Re: TS-Clearwire-034-091120
Clearwire Corporation
Request for an order to approve tower sharing
at an existing telecommunications facility
located at 52 Stadley Rough Road, Danbury

Re: TS-Clearwire-034-091120
Clearwire Corporation
Request for an order to approve tower sharing at an existing telecommunications facility located at 52 Stadley Rough Road, Danbury

At the request of the City of Danbury, I write to offer the following preliminary comments on two applications recently filed by Clearwire Corporation regarding the cellular tower facility located at 52 Stadley Rough Road in Danbury. The first application is dated November 20, 2009 and is entitled "Tower Sharing Application" (the "Application"). The second application is dated December 18, 2009 and is entitled "Notice of Exempt Modification" ("Notice"). The latter application apparently was filed at the request of the Siting Council. It is my understanding that the Council intends to consider the Application at its meeting on January 7, 2010. Nevertheless, I would like to take this opportunity to comment on both the Notice and the Application.

2 OF 3

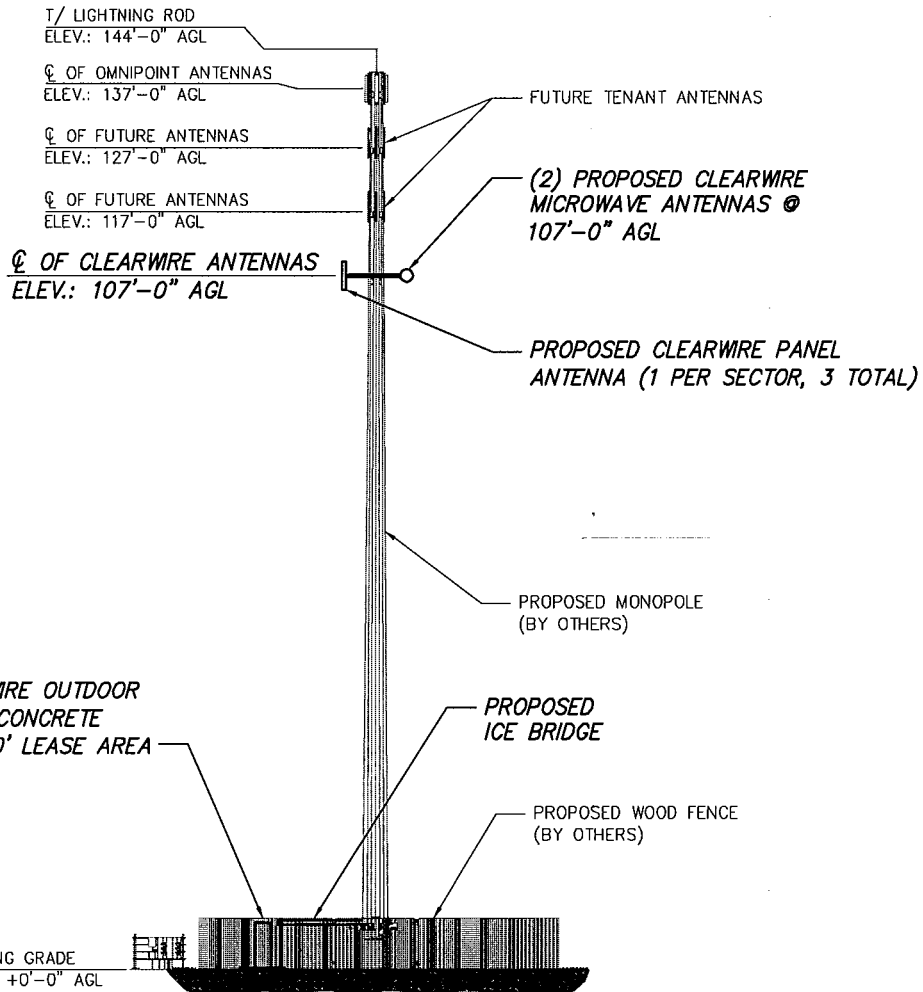
4. The "lease exhibit" attached to both the Notice and the Application (sheet 2 of 3, dated November 18, 2009) shows the Clearwire antennas and dishes as platform mounted. There also appear to be internal inconsistencies in the designs of the antennas and their mounts. (Compare FDH December 10, 2009 report, Drawing E-1 with Sheet 2 of 3 (dated November 18, 2009).

- d. On page 7 of the December 10, 2009 FDH report, the proposed carriers are shown on the tower as not being flush mounted.
 - e. There were no calculations in either FDH structural report provided to verify any of the assertions in either of the FDH reports.
